## REMARKS

**ANNOTATED VERSION OF MODIFIED CLAIMS TO SHOW CHANGES MADE**

FIG. 5

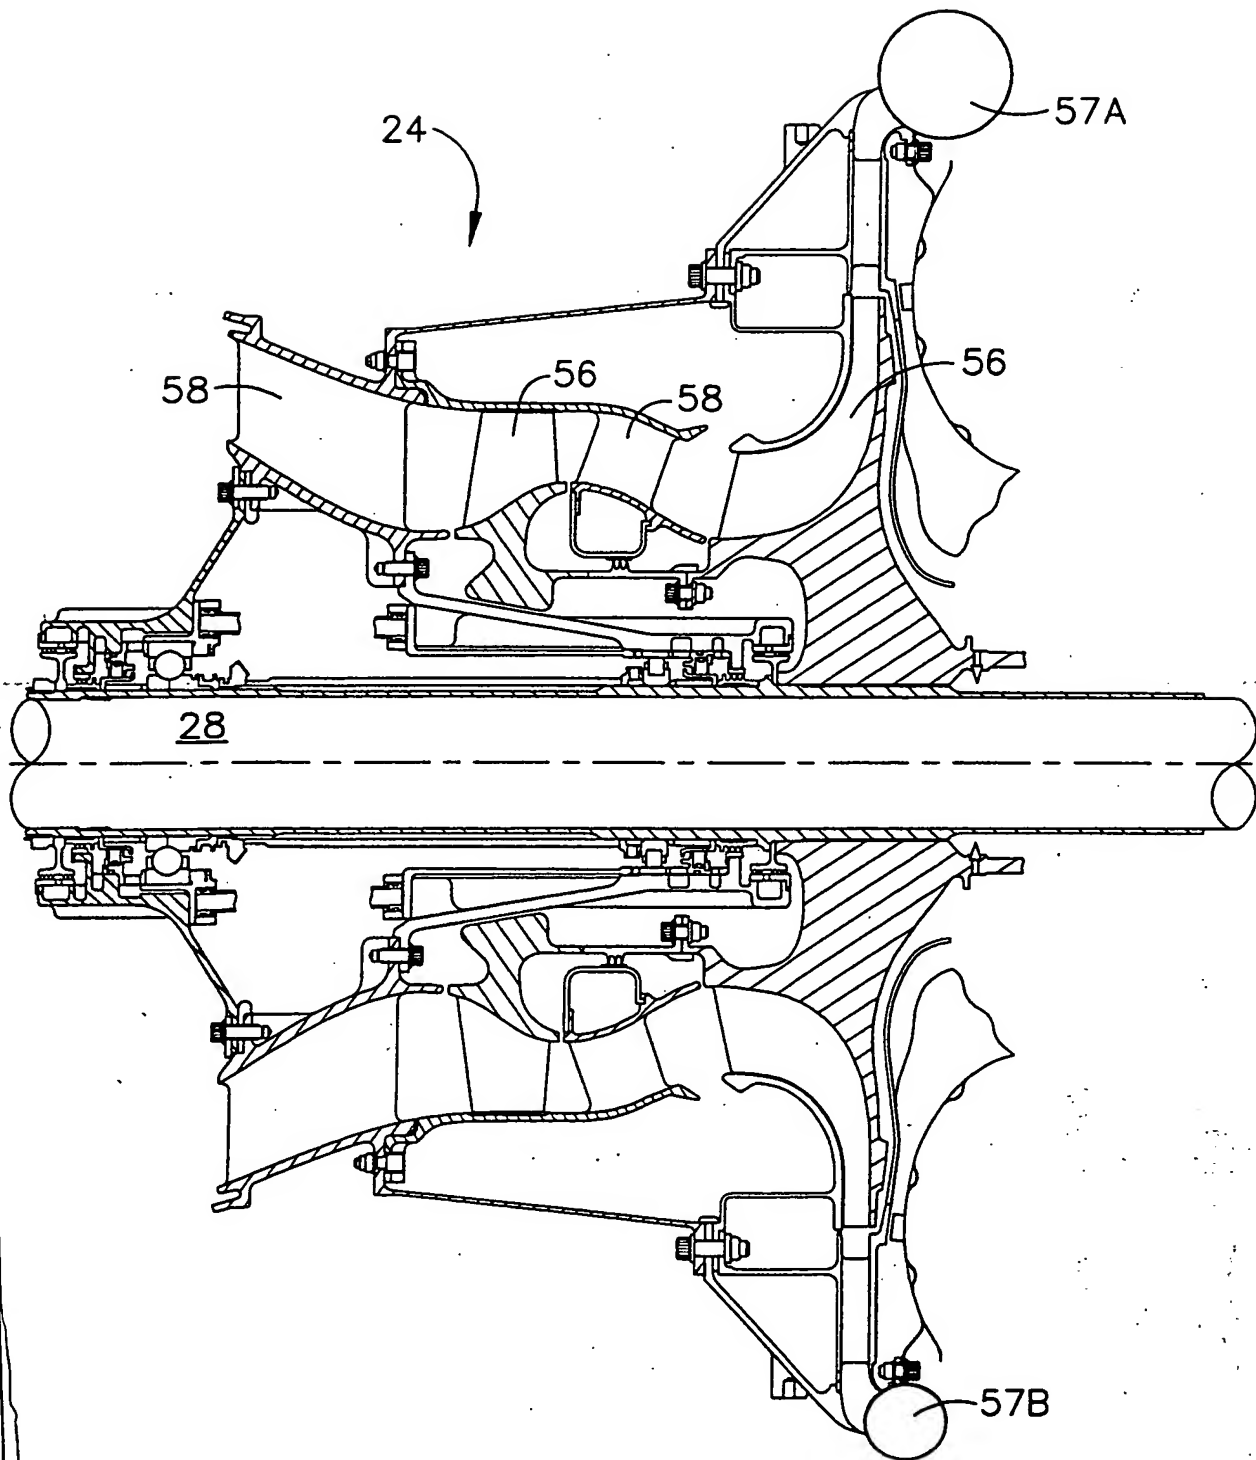
FIG. 5 has been cancelled and new FIG. 8 has been submitted in schematic form as suggested by the Examiner. The specification has been amended as required by the Examiner to delete the language about two rotating disc. Number 56 and 58 have been deleted from the specification as they are not included in the new FIG. 8. By deleting the new matter, the reissue Declaration is no longer defective. An executed Declaration that the original patent was lost is enclosed.

[FIG. 5 is a cross-sectional view of the compressor of the destruction device of FIG. 2;]

[As discussed briefly above, compressor 24 suitably comprises the compressor of power generator 12. With momentary reference to FIG. 5, compressor 24 preferably comprises alternate respective sets of rotating blades 56 and stationary blades 58. Rotating blades 56 are suitably rotated through rotation of shaft 28, which is briefly noted above, is initially activated by generator 20. In accordance with a preferred aspect of the present invention, compressor 24 comprises a multistage compressor, more preferably a two stage compressor, i.e. there are at least 2 rotating blades (impellers) 56 within the body of compressor 24.]

CANCELLED

FIG. 8 is schematic drawing of a two stage compressor of the destruction device of FIG. 2.

As discussed briefly above, compressor 24 suitably comprises the compressor of power generator 12. With momentary reference to the FIG. 8, compressor 24 preferably comprises alternate respective sets of rotating blades and stationary blades. Rotating blades are suitably rotated through rotation of shaft 28, which is briefly noted above, is initially activated by generator 20. In accordance with a preferred aspect of the present invention, compressor 24 comprises a multi-stage compressor, more preferably a two stage compressor.
